NOTICE OF DECISION

RE: DR99-09 A (PDR2019-19-196): Cooper Square CSP Amendment

SIGN CRITERIA for COOPER SQUARE

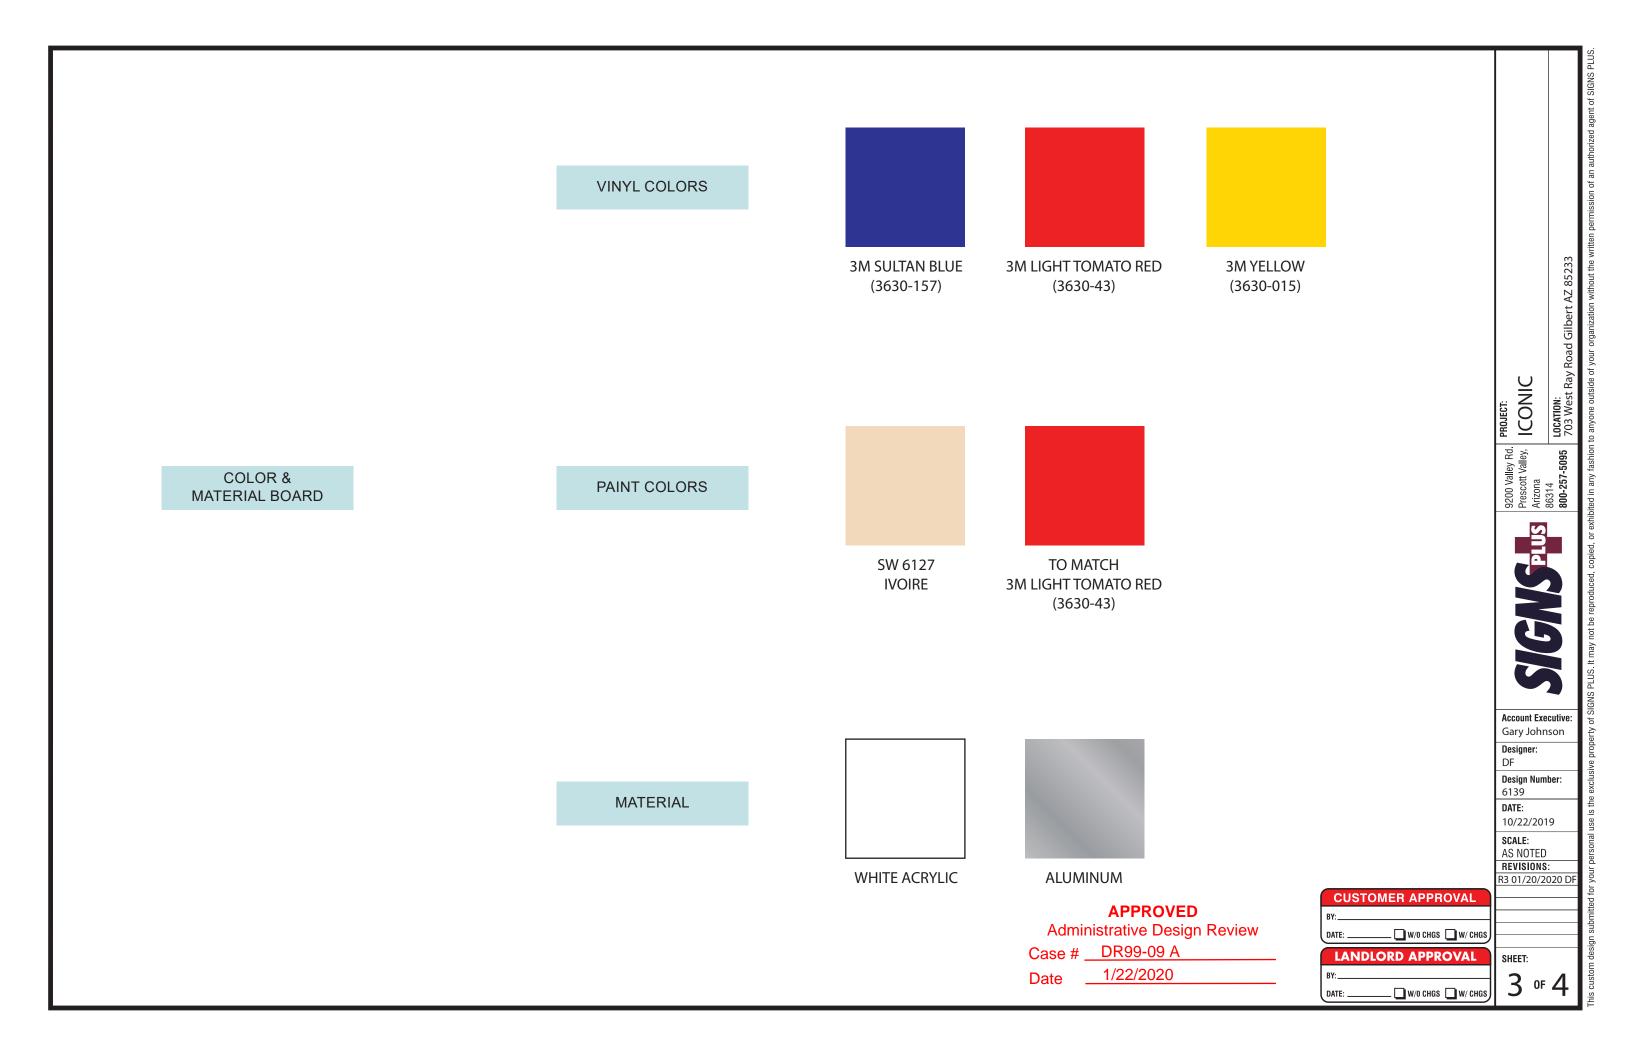
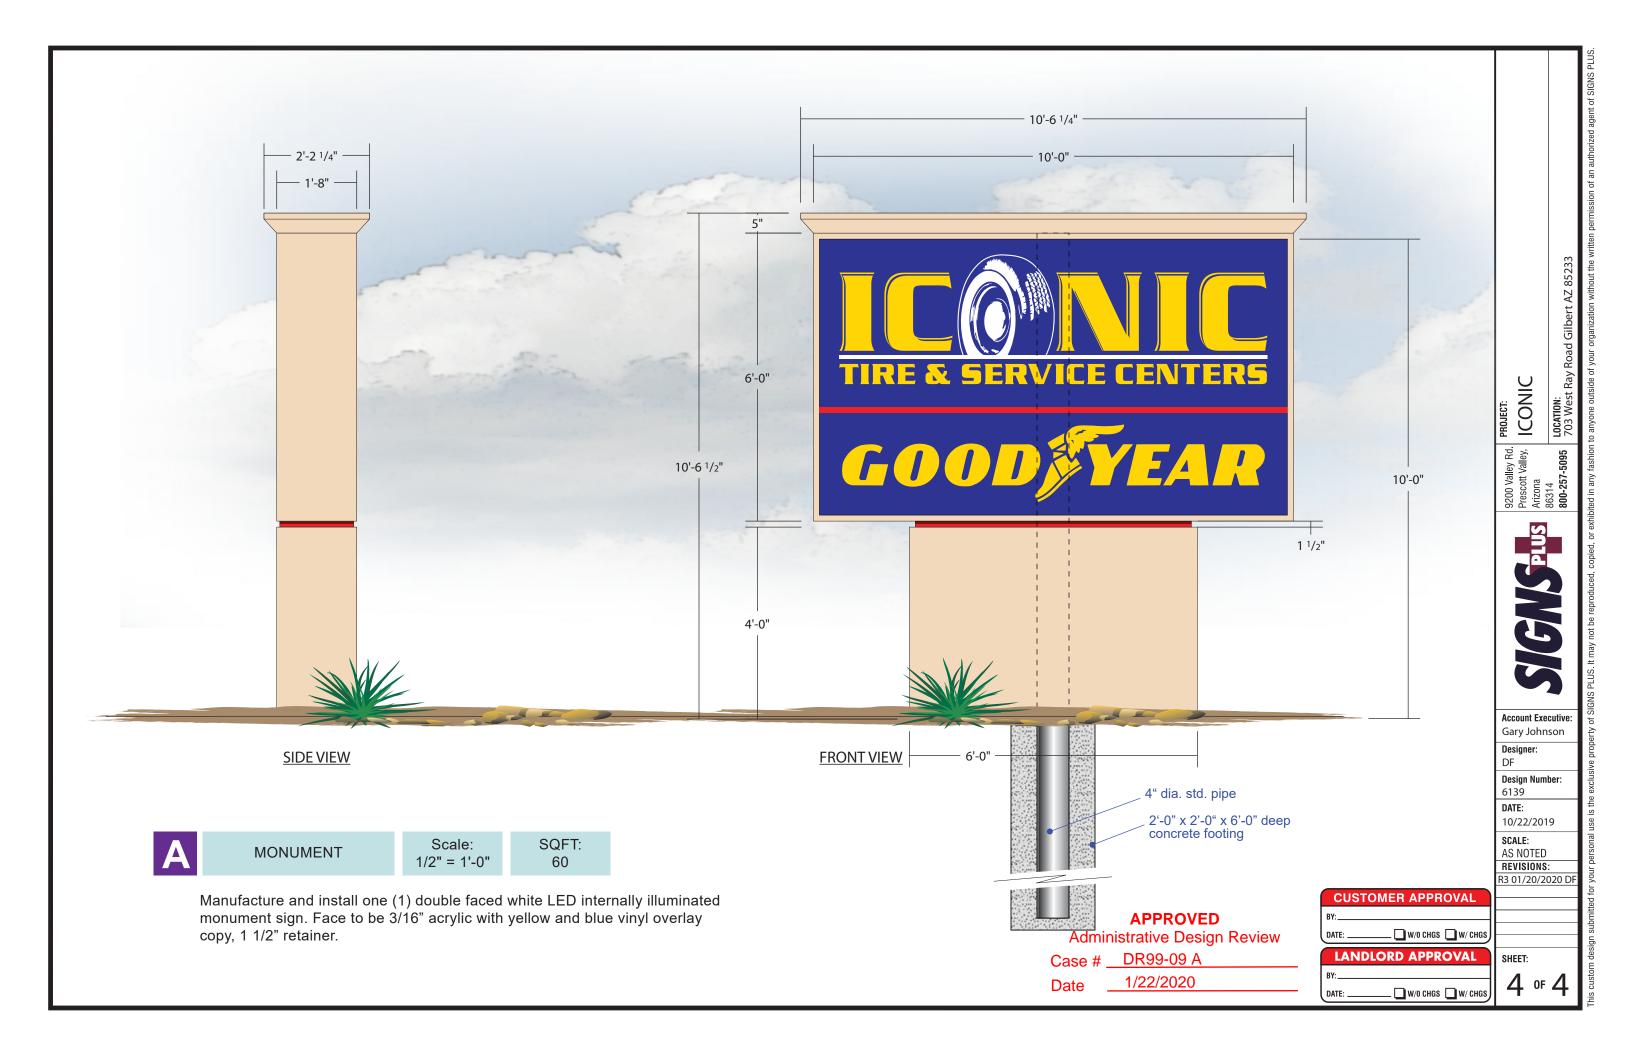
- Comprehensive Sign Plan for Cooper Square located at the southeast corner of Cooper and Ray Road amending the text and allowing for the addition of a monument sign for Iconic Tire.
- No monument sign shall be located within a Public Utility Easement or be located closer than 3 foot to a public right-of-way.
